Informal document GRB-65-26
(65th GRB, 15-17 February 2017
agenda item 4 (b))

Modifications proposed to ECE/TRANS/WP.29/GRB/2017/2

Measuring method to evaluate compliance with the Additional Sound Emission Provisions

Figure 1
Flowchart for the assessment concept for ASEP according to Annex 7

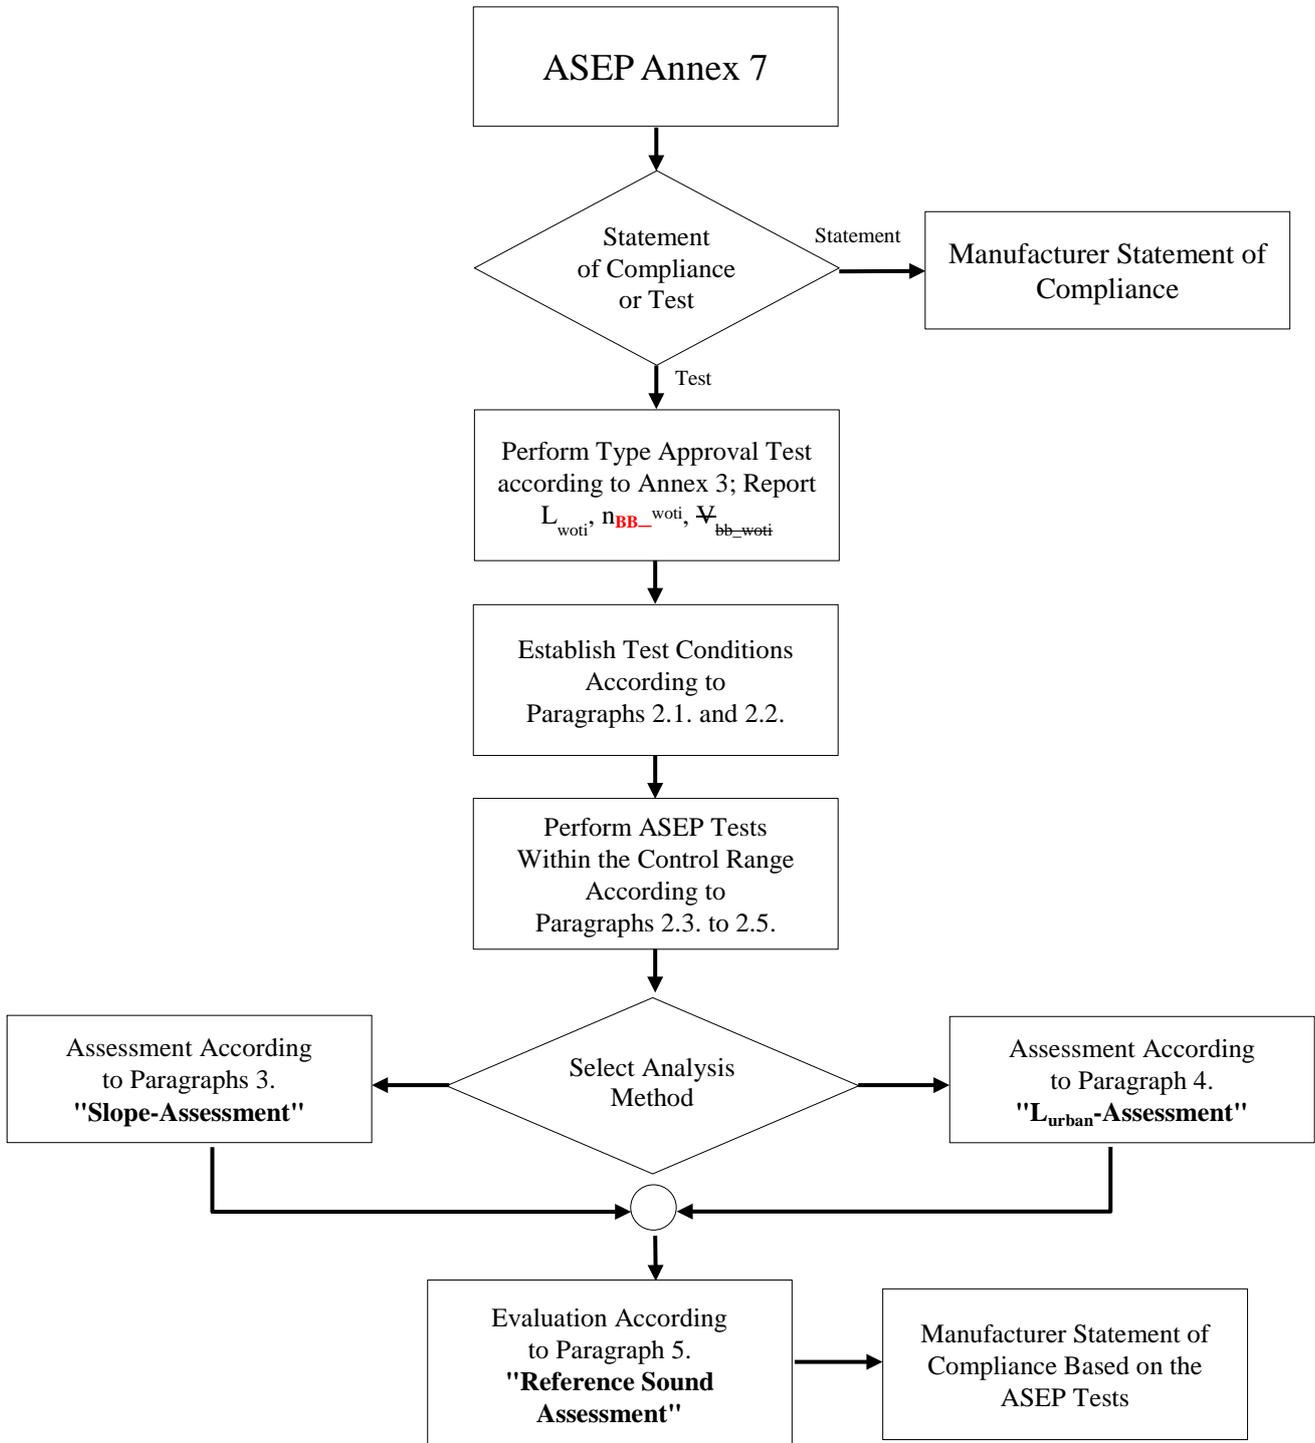
- 1.12. Flowcharts were introduced.
 2. To facilitate reading and understanding, the text was re-structured.
 - 2.1. Some paragraphs were renumbered.
 - 2.2. The sentences of paragraph 2.4. were moved to paragraphs 2.3. and 2.5.1.
